Re: J.E.D. Solid Waste Management Facility
SW WACS ID #89544
Osceola County

**Florida Department of
Environmental Protection
Inspection Checklist**

Facility Name: J.E.D LANDFILL (F/K/A OAK HAMMOCK DISPOSAL)

Erosion and exposed waste Cell 8

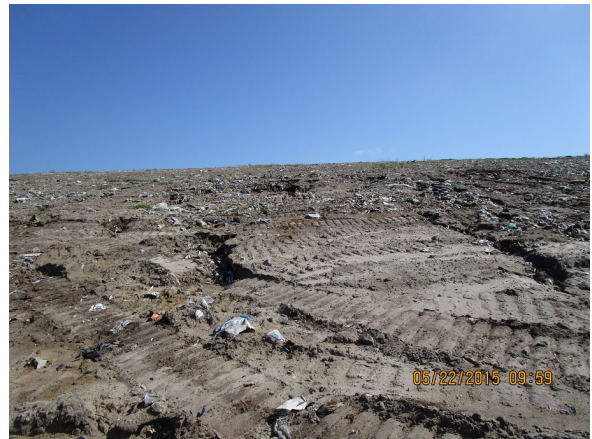
Explanation: Erosion and exposed waste was noted on the south slope of Cell 8.

A large area on the south slope of Cell 8 was eroded and waste was exposed. The facility should be repairing areas of erosion as they appear so that large areas do not become eroded and waste does not become exposed. After discussion with John Hartings and Bob Walls, it was agreed that the facility would send pictures of the eroded area covered and repaired by July 1st.

Corrective Action: The facility shall complete repairs to the slope by June 30, 2015 and submit pictures to the Department of the repaired area by July 1, 2015.

On June 29, 2015, the facility submitted documentation to the Department showing the completed corrective actions.

On June 29th, the Department received pictures of the south slope of Cell 8 covered and repaired.
